CORPORATION OF THE TOWNSHIP OF ESQUIMALT

DESIGN REVIEW COMMITTEE AGENDA

DEVELOPMENT PERMIT and DEVELOPMENT VARIANCE PERMIT
1310 Esquimalt Road
[PID 029-072-883, Lot 1, Esquimalt District, Plan EPP28097]

**SUBJECT: DEVELOPMENT PERMIT and DEVELOPMENT VARIANCE PERMIT
1310 Esquimalt Road
[PID 029-072-883, Lot 1, Esquimalt District, Plan EPP28097]**

Site Plan

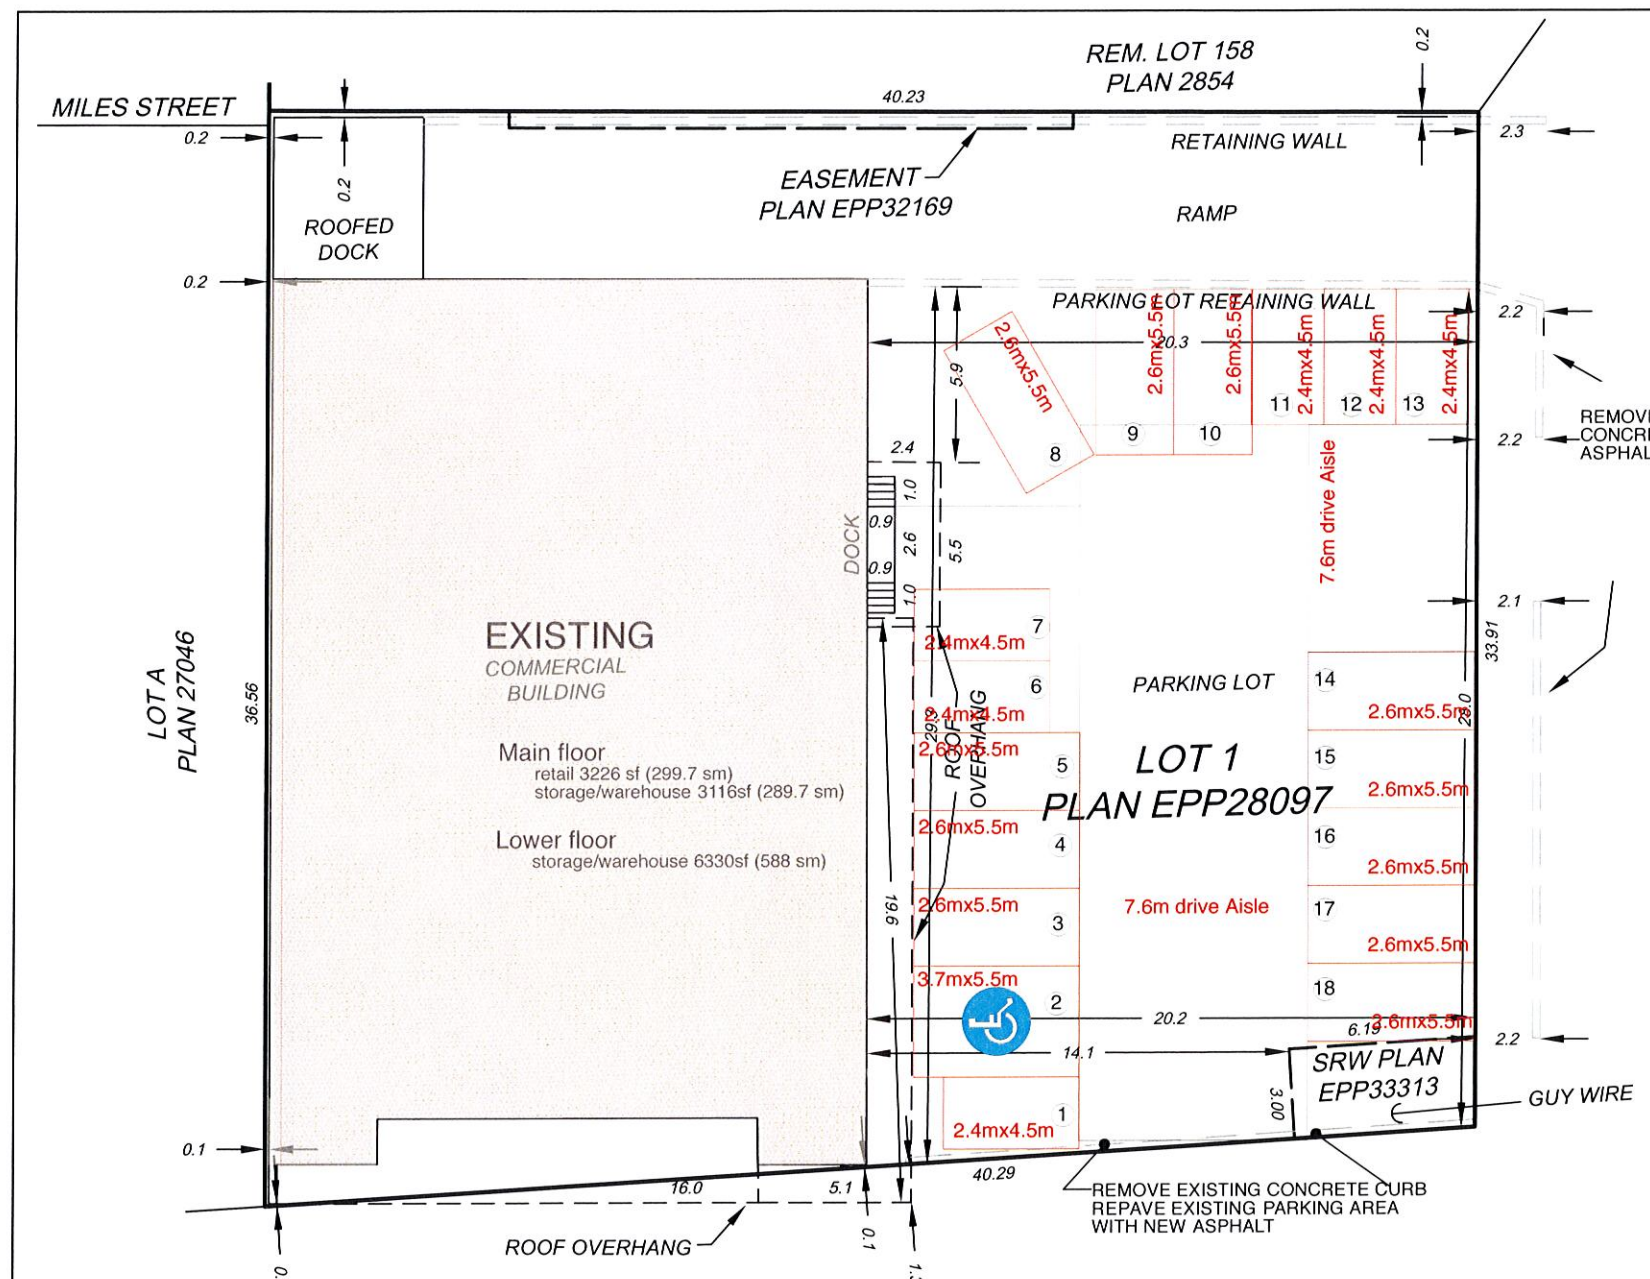
Parking Bylaw, 1992, No. 2011, Section 13(1)(a)(iv) – Parking Requirements – Number of Off-Street Parking Spaces – A reduction to the number of required off-street Parking Spaces, from 1 spaces per 25 m² gross floor area to 1 spaces per 64 m² gross floor area [ie. 47 spaces to 18 spaces];

Parking Bylaw, 1992, No. 2011 requires retail businesses to provide 1 parking space per 25 square metres of gross floor space. The building on the subject property was originally built with a BC liquor distribution warehouse on the lower level; therefore there is actually considerable storage for the proposed retail store. Customers will only have access to the main floor level of the store. The area of the main level at 550 m² requires 22 parking spaces, the parking lot will have 18 spaces.

1 SOUTH ELEVATION (ESQUIMALT ROAD)
SCALE 1/8"=1'-0"

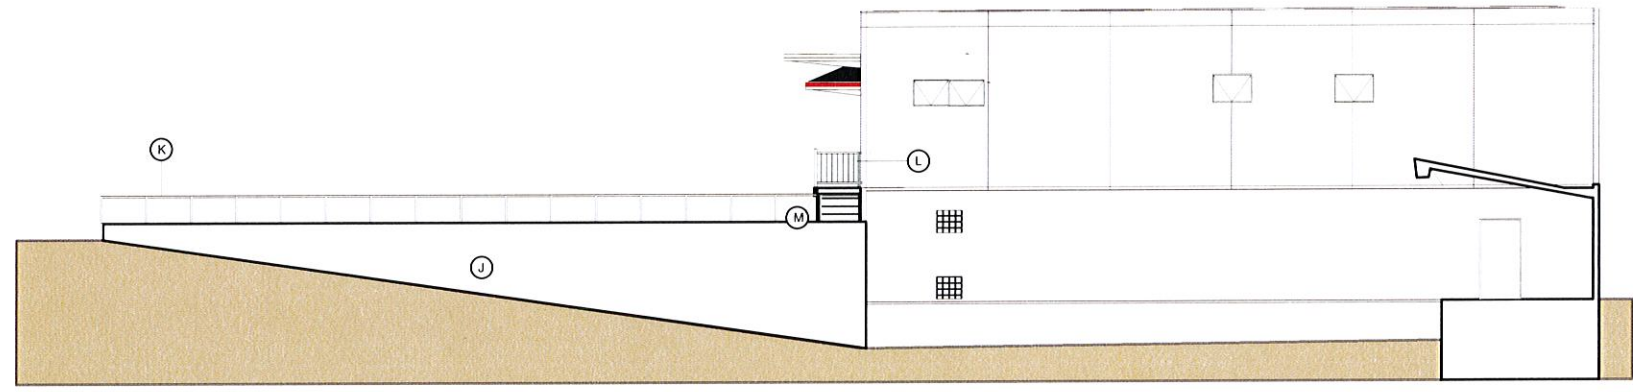
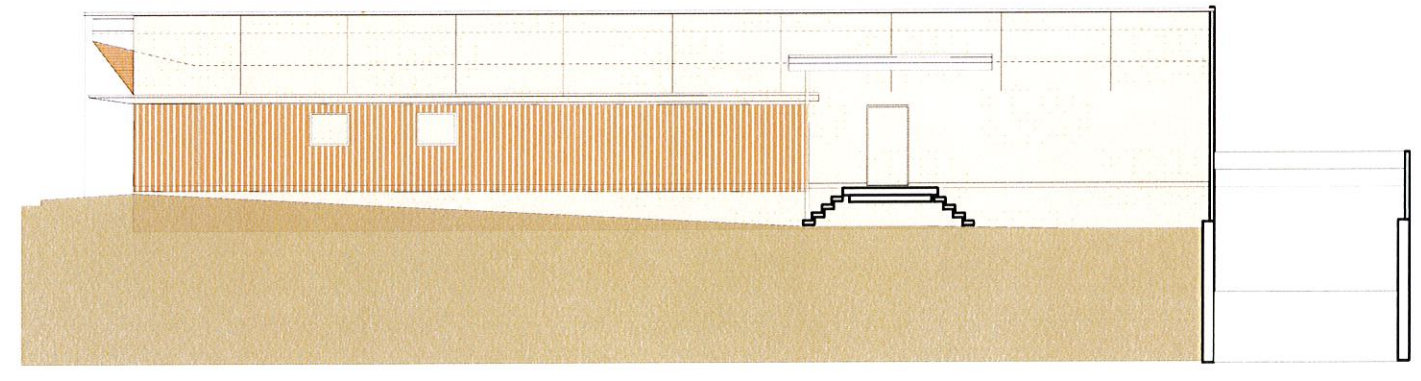
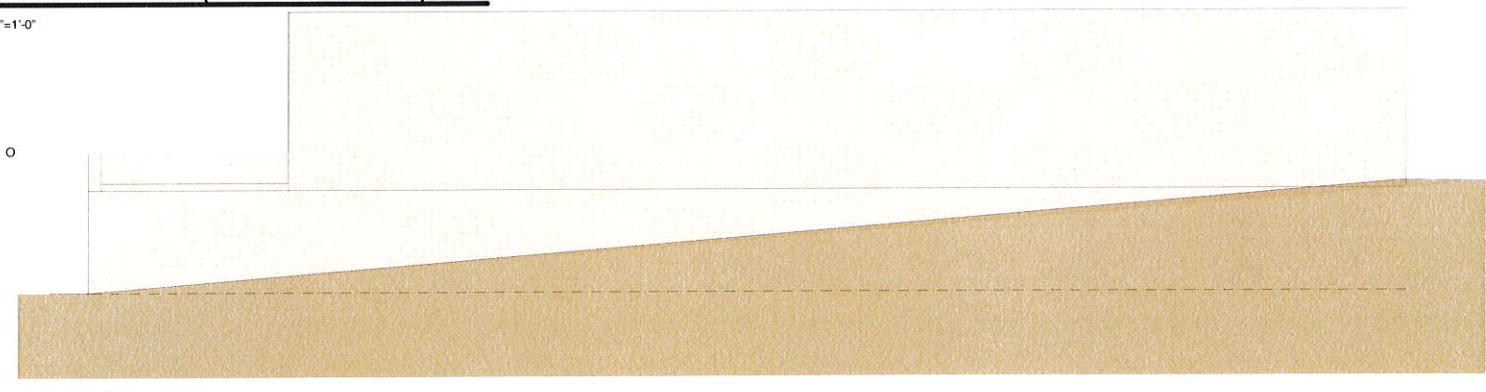
Sign Regulation Bylaw, 1996, No. 2252, Section 9.6.3 - Fascia Sign - Area and Dimensions – An increase to the restriction that Fascia signs not cover more than 15% of the area of a building façade, for the south elevation. [ie. from 15% to 17%];

Sign Regulation Bylaw, 1996, No. 2252, Section 9.16.1 – Wall Sign – Number Permitted – A relaxation to allow one Wall sign on an elevation of the building that also has Fascia Signage, for the east elevation.

Three of the signs [signs A, B and C] are defined as 'Fascia' signs with the fourth sign [sign D] being a 'Wall' sign. On the south elevation of the building the proposed 'Fascia' signage slightly exceeds the percentage of the building façade that can be covered with signage; therefore, a variance is requested to allow a two percent increase to the 15% maximum façade coverage permitted in the sign bylaw, from 15% coverage to 17% coverage.

On the east elevation of the building a 'Wall' sign [sign D] is proposed for the same elevation that already has a 'Fascia' sign. The Sign Bylaw only allows a Wall sign on a building elevation that does not have any other signage; therefore, a variance is being requested for 'Sign D'.
